This objection follows assessment of application 25/00406/APP by the Wendover HS2 Mitigation Action Group. We believe the overall application is flawed, incomplete and contrary in places to planning regulations and HS2 Construction Code of practice (CoCP) and should be rejected and re-submitted addressing the points made in this objection. Commentary is included about the deficiencies in the design, the Implementation and Traffic Management Plan (CPTMP), and the Ecological Impact Assessment. These are summarised in a set of Material Grounds for Objection to the application; and a set of requested Planning Conditions that should be incorporated should the Council determine nevertheless (against our wishes) to accept the proposals.

1.0 Objection

Figure 1 Proposed Planning Area and Fenceline in Relation to Existing Trees, Hedgerows and Infrastructure

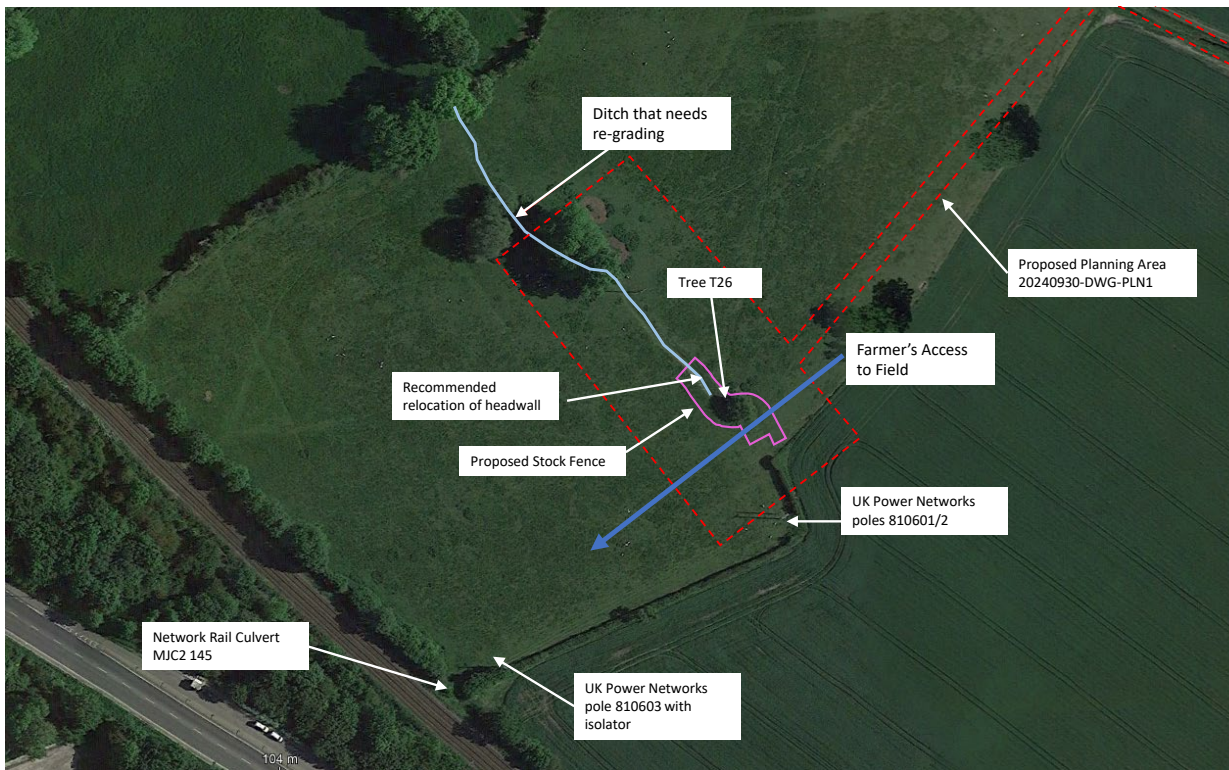
- iv. The design of the fence line will cause an obstruction that will prevent the farmer accessing and enabling livestock to the western section of the field. Refer to Figure 1.

- vii. The vegetated head wall could be moved 25m northwards down the stream with an extension to the 225 mm outgoing pipe. This negates the need to remove the tree T26 and the fence and thus providing a place for backfill of excavations arising, and facilitating access to the western area of the field. Refer to Figure 1.

- i. Access to the section of the field beyond the proposed chamber will be prevented by the current proposed fencing layout for the farmer and livestock, as well as UK Power Networks and Network Rail to maintain their assets¹;

- i. That the design is only accepted on the basis that the headwall is moved to negate the need for both a stock fence and the removal of field maple T26;

Figure 2 Spring Chamber site between Tree 26 and hedgerow (both affected by the construction)

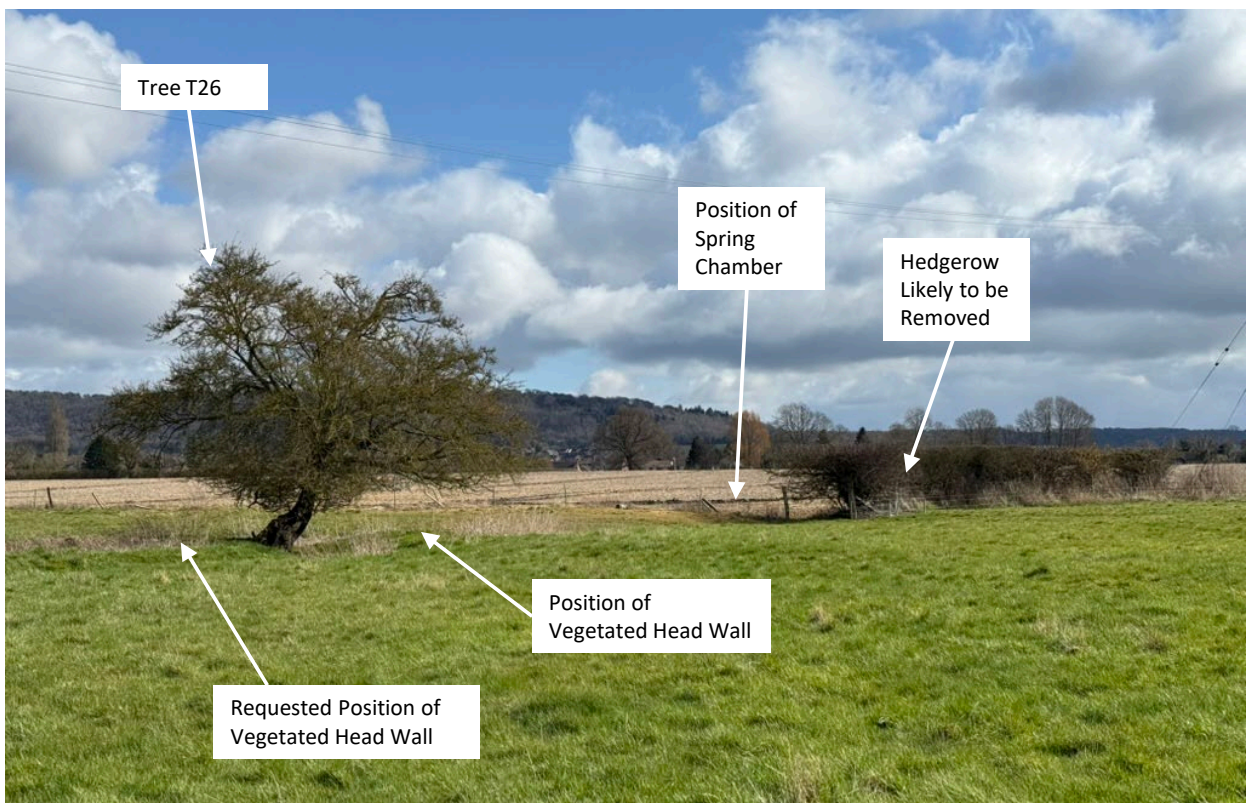
- b. Network Rail from maintaining its culvert MCJ2 145. Refer to Figures 1 to 4.
- vi. The current location of the chamber and surrounding backfill is such that to construct the chamber it will be necessary to remove a section of existing hedgerow, contrary to the statement made in para 5.3.3. of the Ecological Impact Assessment. Refer to Figure 2.

- i. The location of the chamber is such that removal of a section of hedgerow will be necessary and no mitigation replanting of this section is presented;
- ii. Efforts have not been made in the design to mitigate ecological damage from the loss of the Field Maple T26, which could be avoided by simply moving the headwall and extending the discharge pipe. See Figure 2;

- ix. That replanting of removed hedgerow is included in a re-instatement landscape plan;
- x. That the Applicant contributes, in full, to re-surfacing of the full extent of Dobbins Lane and the approaches from South Street;
